**SERVICE LETTER NO. 71-11A**  
**Supersedes Service Letter No. 71-11**

**SUBJECT:** Bungee Inspection

**SERIALS AFFECTED:** All Model AA-1 and AA-1A aircraft.

Figure 1. Bungee Assembly

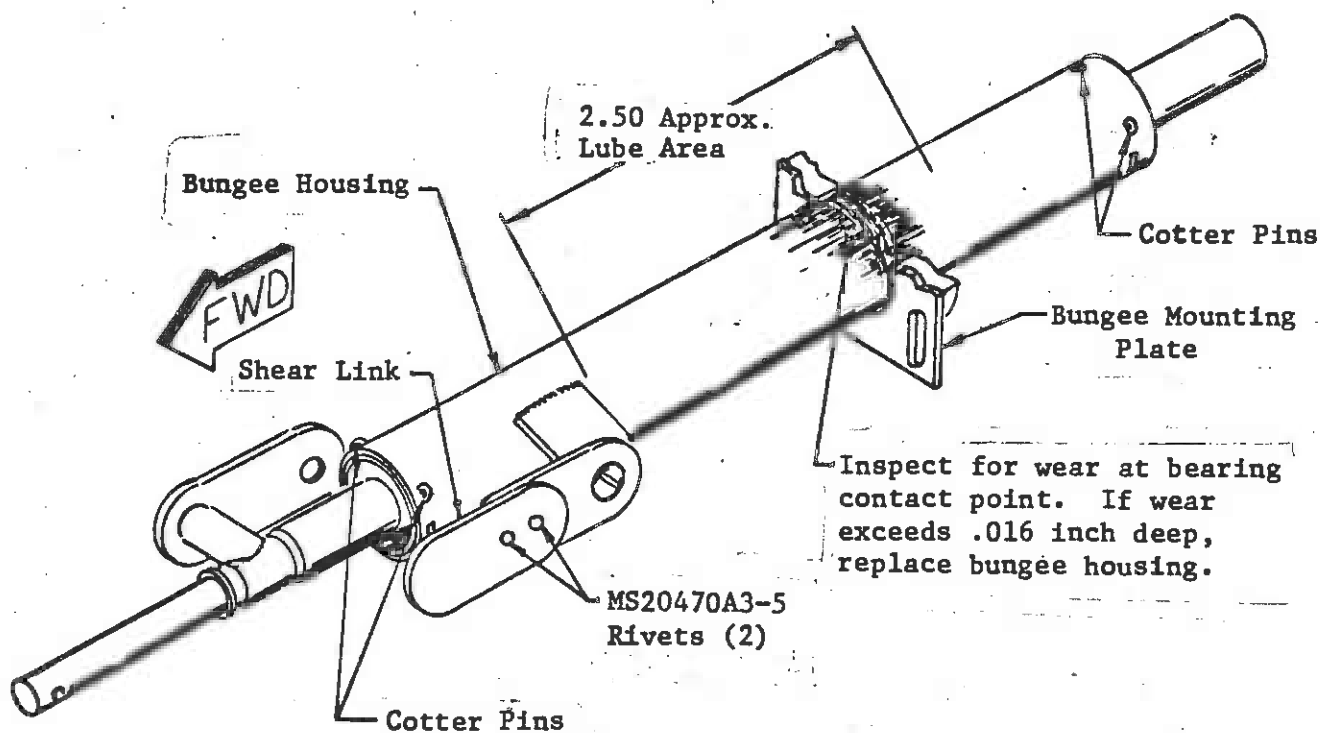
Field reports indicate that on aircraft with 500 or more hours, the bungee housing outer surface may show excessive wear at the support bearing, or the rivets, which secure the shear link, may have become loose (See Figure 1).

1. Inspection of the bungee housing outer surface. If wear is more than .016 inch deep, the bungee housing assembly (part no. 607004-701) \$19.72 (H), should be replaced.

2. Inspect two (2) MS20470A3-5 rivets in shear link. If loose rivets are found, they should be replaced with identical soft rivets, or the shear link (part no. 607004-503) \$2.08 (H), should be replaced.

1. Remove the tailcone after disconnecting the taillight wire.
2. Disconnect the link that attaches the bungee housing to the elevator down cable at the elevator bellcrank.
3. Remove the four (4) cotter pins securing the bungee housing to the bungee shaft assembly and discard them.
4. Remove the two (2) bolts and nuts holding the bungee mounting plate and slide the plate off the housing assembly.
5. Slide off the old bungee housing and slip on the new bungee housing assembly. Lubricate outer surface of bungee housing as shown on Figure 1 with McLube #1708 (McGee Chemical Co.) or equivalent.
6. Slide on the bungee mounting plate, line up the cotter pin holes and secure the housing assembly with four (4) cotter pins (AN380-2-4) furnished. If needed, cotter pin holes may be cleaned up with a #50 (.070 dia.) drill.

The replacement bungee assembly will be supplied with the shear link that attaches the bungee housing to the elevator down cable undrilled at the cable attach end.

7. Install the two (2) bungee mounting plate bolts, nuts and friction pad, but do not tighten at this time. When installing the new bungee housing assembly, lock the elevators at  $0^{\circ} \pm 2^{\circ}$  and the trim tab in the  $3^{\circ} \pm 1^{\circ}$  down position. Then, with the bungee completely unloaded, align the undrilled shear link with the elevator down cable bellcrank attaching bolt and mark the proper location for the bolt hole in the link.
8. Remove the link and drill a .186/.189 inch diameter hole at the pre-marked location.

The original shear link may be used providing that hole alignment has been verified.

9. Carefully reassemble the link to the bungee housing noting that all moving parts are properly aligned and free from friction.
10. Actuate elevator full travel up and down and adjust bearing mounting plate as required to allow bungee housing to slide freely through the bearing and tighten the two (2) attaching bolts.
11. Connect taillight wires and reinstall tailcone.
